February 11, 2020
Revised March 24, 2020

RE: Reconsideration Letter and Additional Comments Regarding Site Investigation Addendum for the Block System Cleaners Facility Located at 2017 Winnebago Street in Madison, Wisconsin – BRRTS No. 02-13-552132; ReadyEarth Project no. 11-0604

B.3.a Geologic Cross-Section Figure A-A'

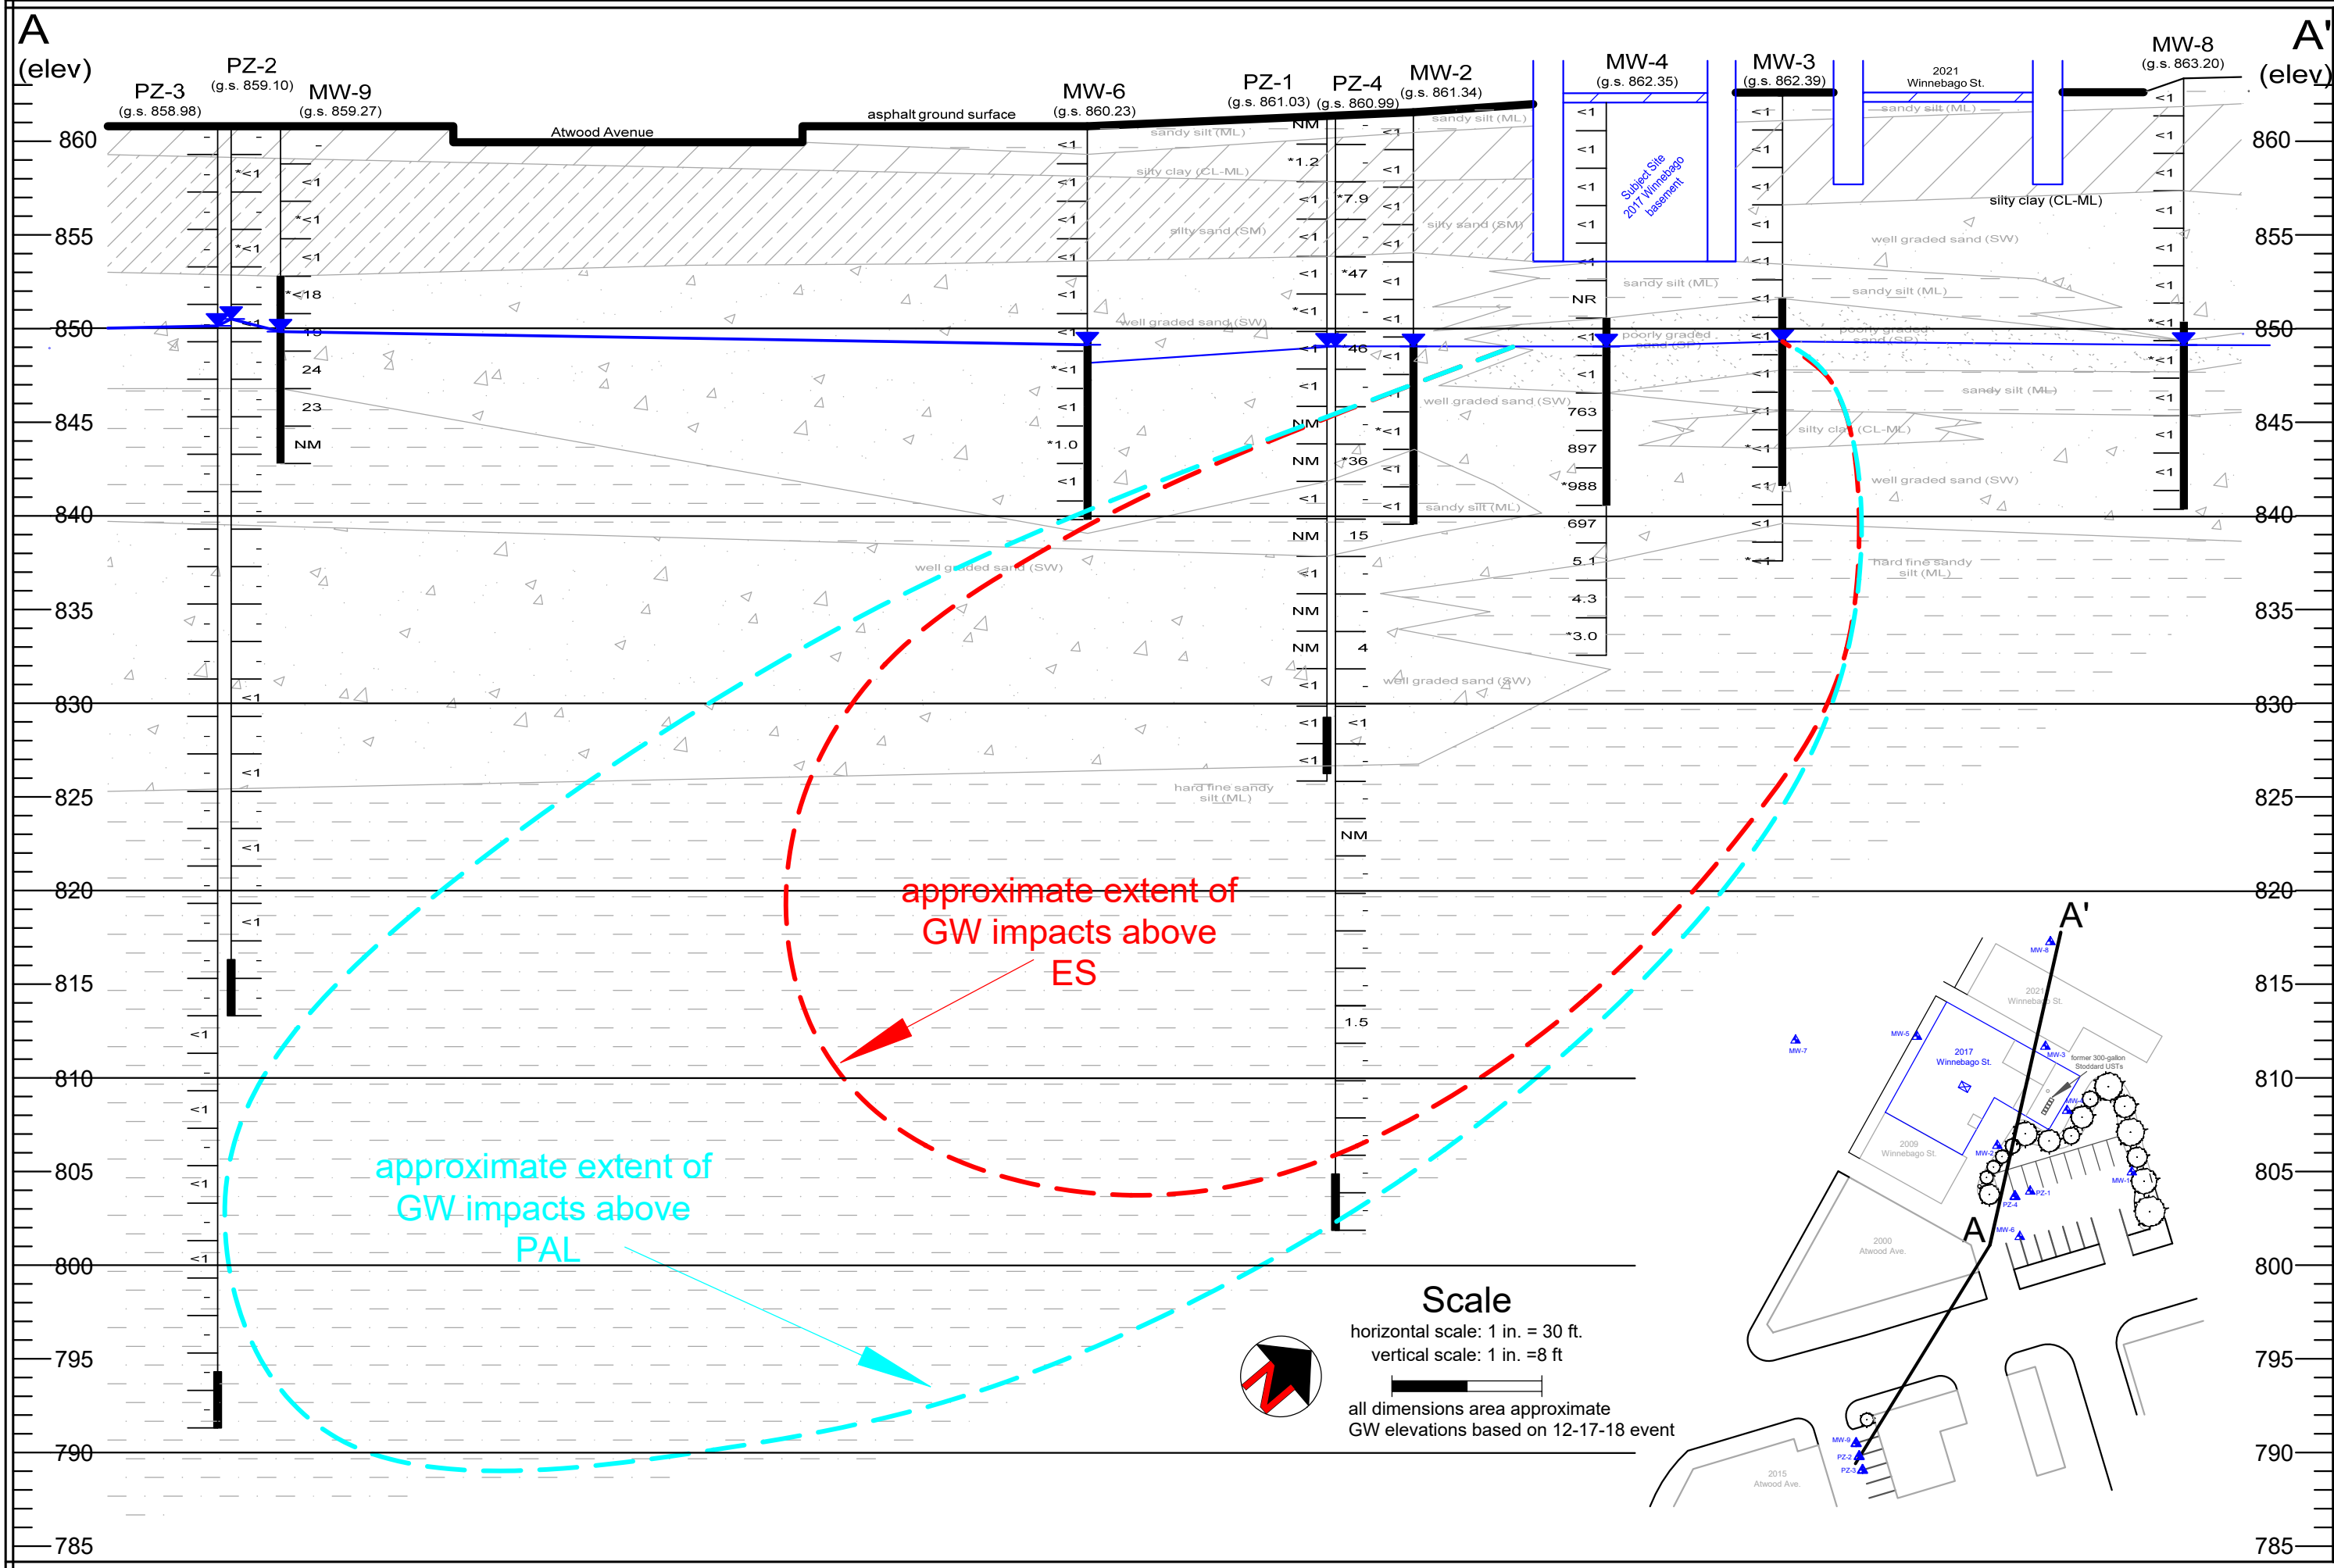
Please refer to figure B.3.a cross-section diagram included in Attachment A. Based on soil descriptions presented on the cross-section diagram, the DNR has questioned whether a preferential pathway exists at depth for plume migration, and whether the piezometers are situated to properly evaluate the plume extent.

1. The two soil types in question are labeled on the cross-section diagram as a “well-graded sand” and a “hard fine sandy silt”. The descriptions on the actual boring logs (included in Attachment A) are as follows:

The two units are a silty sand and a sandy silt. Both units include similar components and are quite similar. However, the units are slightly different and are thus graphically represented differently on the cross-section. Due to their similarity, it is likely that the soil transitioned from one description to the other as opposed to breaking sharply. For sure, the units appeared substantially similar in the field insofar that there was no obvious reason to change the approved scope of work. The term well-graded signifies that there is a wide range of particle sizes and relatively lower porosity compared to poorly-graded sand. To be clear, the sand was not beach sand, was not loose and granular (it was more like concrete as opposed to table salt), and did not visually represent a preferential pathway.

4. The plume extent depicted on the cross-section map is a reasonable representation:
- The angle of the plume is established by the shallow wells MW-4 and MW-6, which are along the centerline of the plume: impacts are present at the top of the water table at MW-4 (based on PID readings and soil lab results at the soil/water interface); the low concentrations at MW-6 indicate only the very bottom of that well is engaged with the plume.

- The degree of the concentrations in the other piezometers as compared to PZ-1, and the relationships of the concentrations in those piezometers to the enforcement standard (ES) and PAL indicate that PZ-1 is centrally-located in the plume and that the other piezometers are peripherally-located in the plume. The corroboration of the shallow and deep wells suggests the cross-section is a good model for the plume.

- A reasonable plume cannot be drawn that would incorporate preferential flow above PZ-2 (certainly not exceeding an ES - i.e. the plume cannot extend beyond PZ-2 without being detected at PZ-2). That plume would be an unnatural contortion that wraps back and then drops vertically 25 feet so that it is only slightly detected and at a lower concentration at PZ-2 than at PZ-3.
